Subject: MHI's Amended Response to US-APWR DCD RAI No. 740-5719 Revision 2 (SRP 06.02.02)

Amended Response to Request for Additional Information
No. 740-5719 Revision 2

RAI NO.:	**NO. 740-5719 REVISION 2**
SRP SECTION:	**06.02.02 – Containment Heat Removal System**
APPLICATION SECTION:	**6.2**
DATE OF RAI ISSUE:	**4/26/2011**

QUESTION NO.: 06.02.02-64

Figure b-1 Film Condensation at Structure Surface

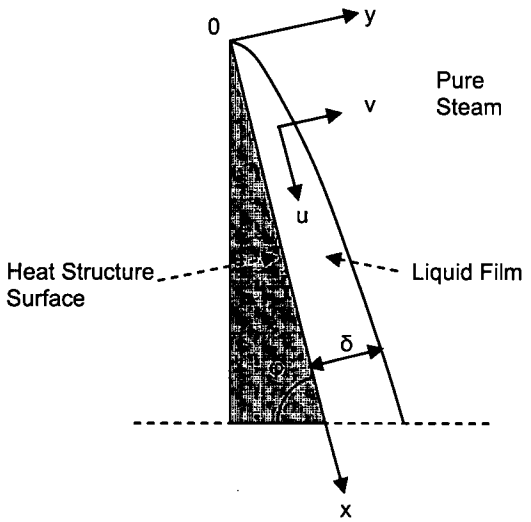
o Condensate water on containment surfaces – Equation listed for film condensation correlation used to calculate film thickness could not be readily verified (reference in Japanese) and was not found in standard textbooks on heat and mass transfer. Appropriate reference and justification should be provided for the applied methodology and selected input values. Film thickness will be a function of the surface height. Justify estimated vertical surface area and corresponding heights

Condensate film thickness was calculated from Eq. 11 in the holdup volume calculation based on the fluid conditions. The calculation follows the methodology of theoretically solving the Nusselt film heat transfer correlation, which is widely known and is referenced from Reference 4 and 5.

Assume constant condensation and liquid flow on structure surfaces (Figure b-1).

By Eq.11, condensation liquid thickness on the surface of the heat structure is predicted. The height used for this calculation was 40 meters (about 130 feet), and the resulting condensation film thickness (based on 40 meters height) was applied to all surfaces. The vertical portion of containment from second floor level (EL 25'-3") is about 129 feet. If the vertical height (x) increases, the liquid film thickness also increases as shown in Eq. 11. However, the liquid thickness calculated based on a 40 meter height was conservatively applied to all surfaces.

Figure b-2: Sketch of flooding overflow curb

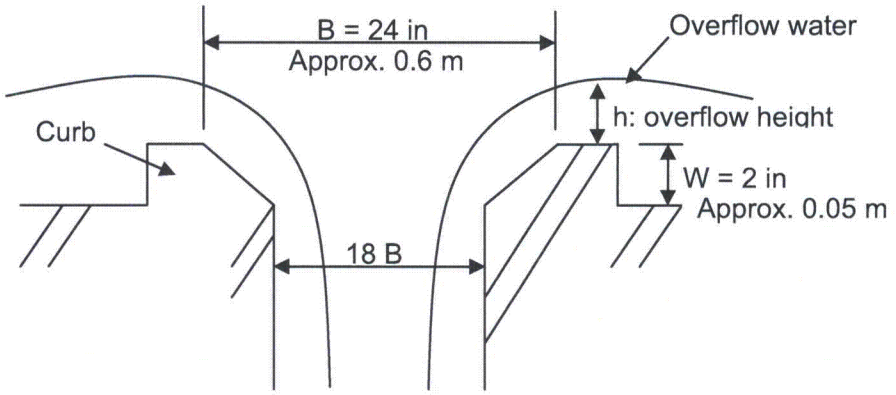
o Water retained on the floors – Reference and basis was not provided for selected equation (method of evaluation) or input values used to evaluate dynamic retention on containment floor (result was 6" water height above floor). No evaluation was provided for assessing the dynamic retention on upper floors in containment (assumed 2" height above floor). Please provide the reference and basis and for calculating the dynamic water retention heights to include method and input values.

Water depth on the floors is calculated based on the following general expressions.

Width of curb is designed to be approximately 600 mm (approximately 24 inches) as shown in Figure b-2. Width of curb shall be as follows;

$h = (Q / (C \times B))^{2/3}$
$= (0.1007 / (2.259 \times 1.9))^{2/3}\ m$
$= 0.082\ m$
$\approx 0.1\ m$ (Roundup)
$\approx 4\ in$
